January 23, 2008

Bureau of Mine Safety

RE: Brookville Equipment Corporation Brookville Model 20T193D 20-Ton Locomotive with a Cummins QSB 6.7 193HP diesel engine and a M267 DST Management System

TITLE
6.7 TURBO WASTE GATE ACTUATOR BLANKET

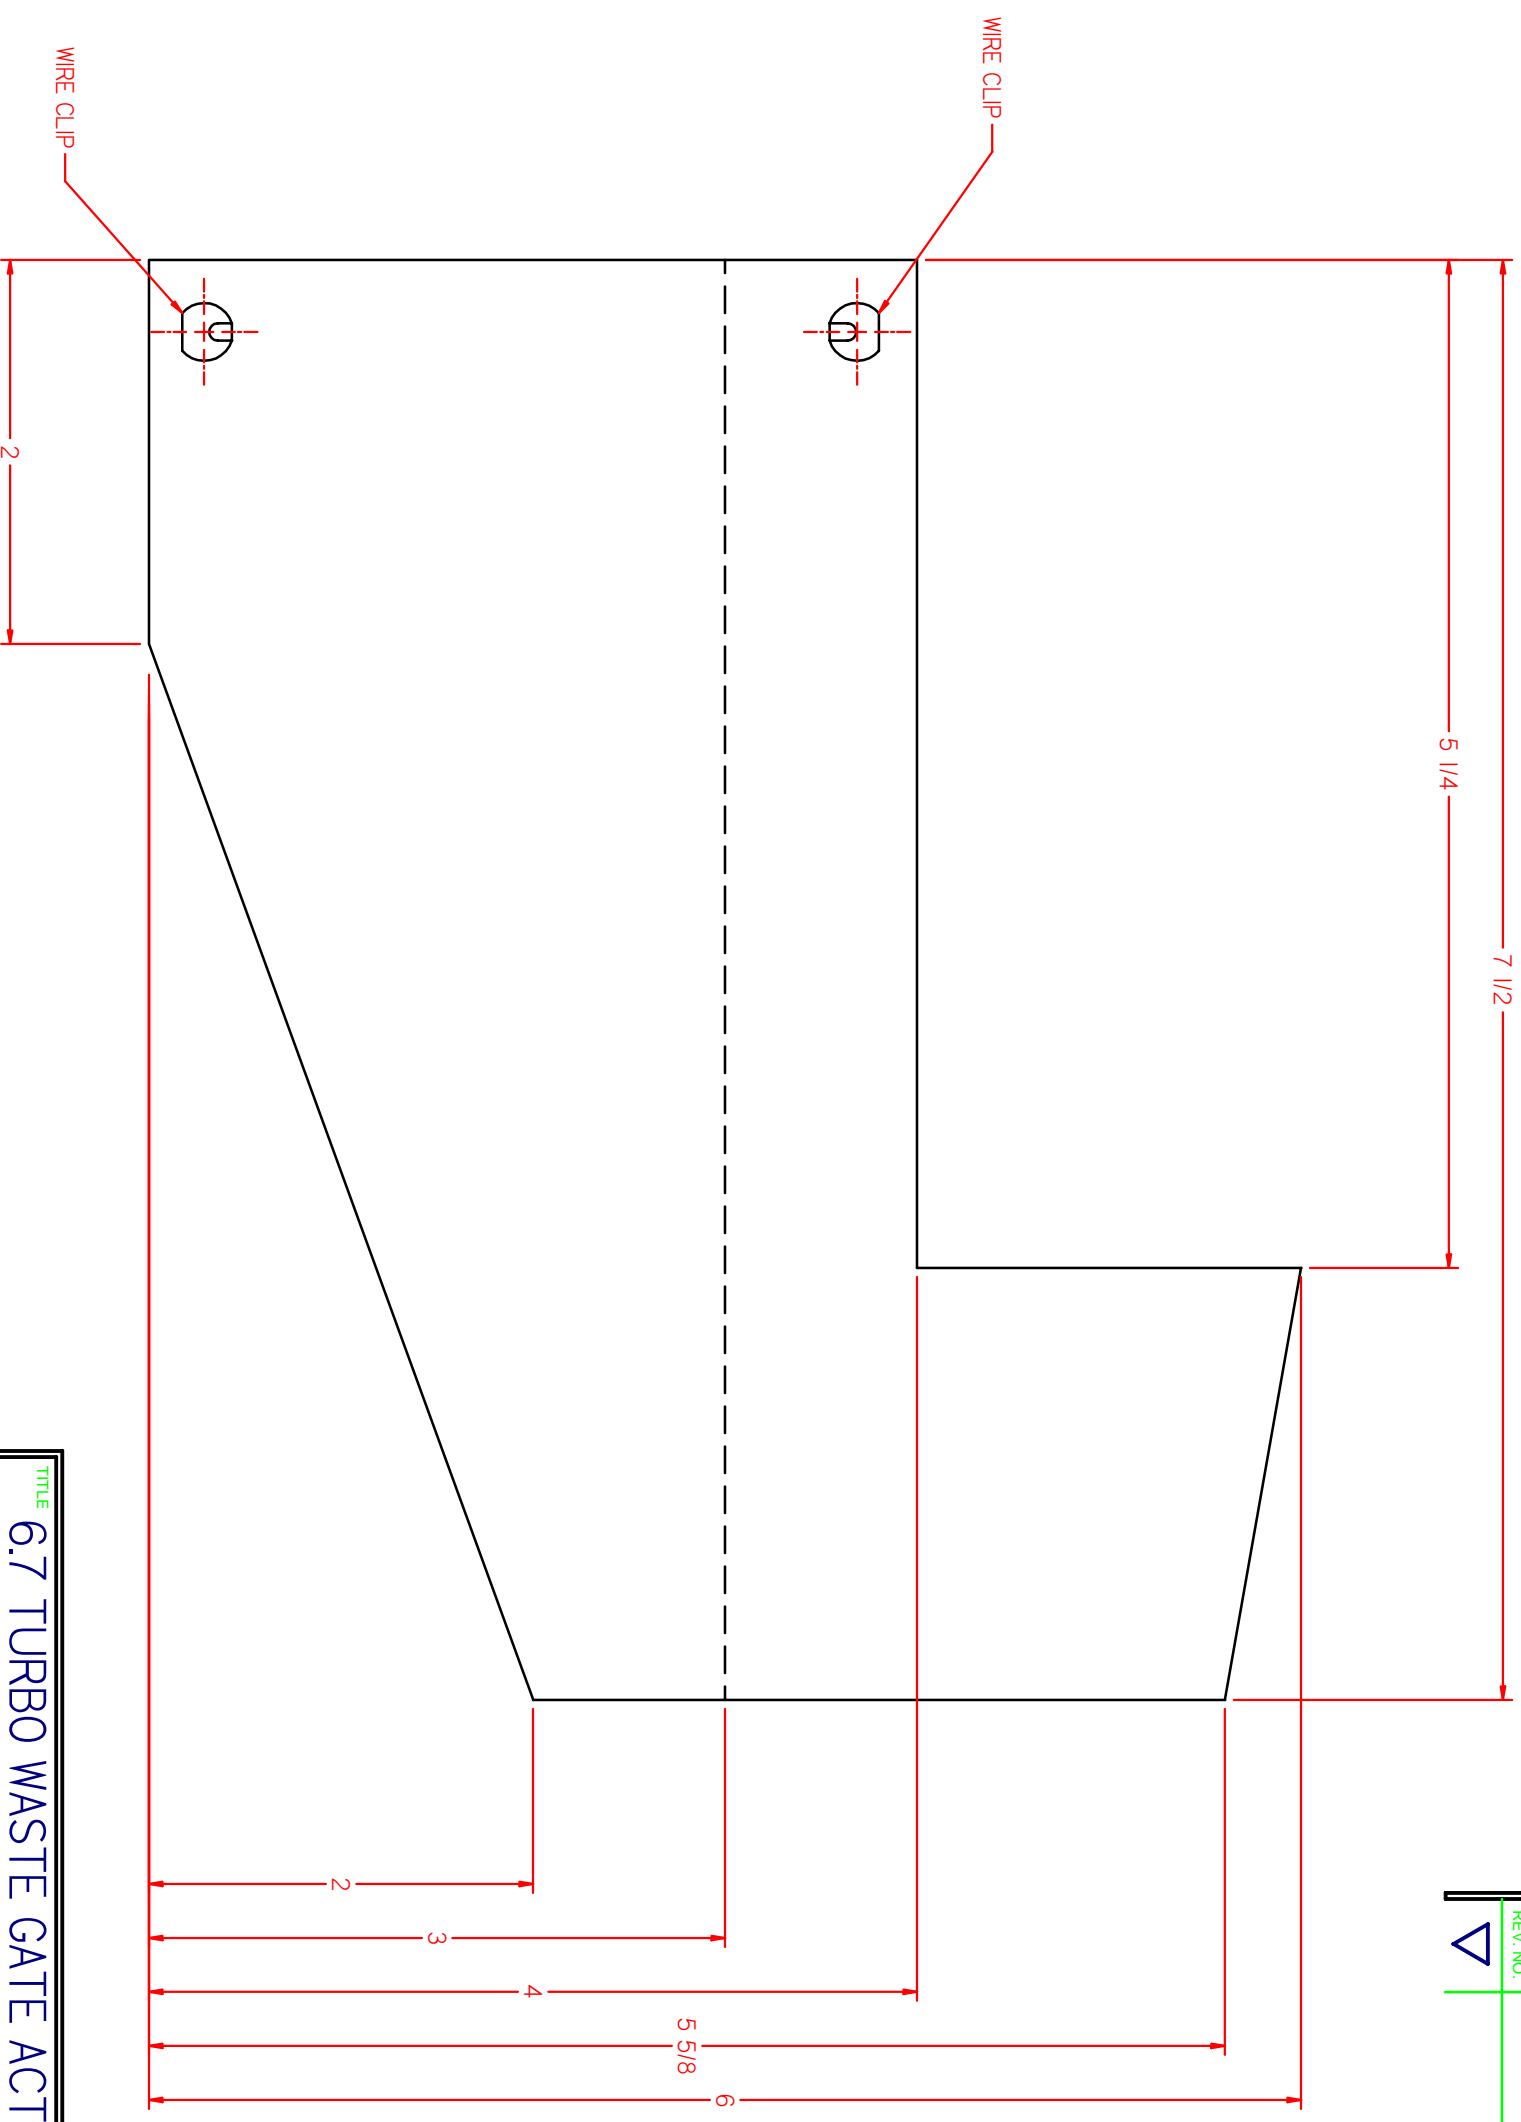
- The temporary "Fire Wrap" material wrap on the turbo arm bracket should be replaced with the permanent "Fire Wrap" part (as shown in Attachment 2) **on the first 100-hour maintenance performed after the part is delivered.** The installation of the permanent wrap shall be noted in the 100-hour maintenance record when it is installed. The BMS should be notified when this permanent part is installed.
- The General Specification Sheet (Attachment 1-Rev) is to be strictly adhered to.
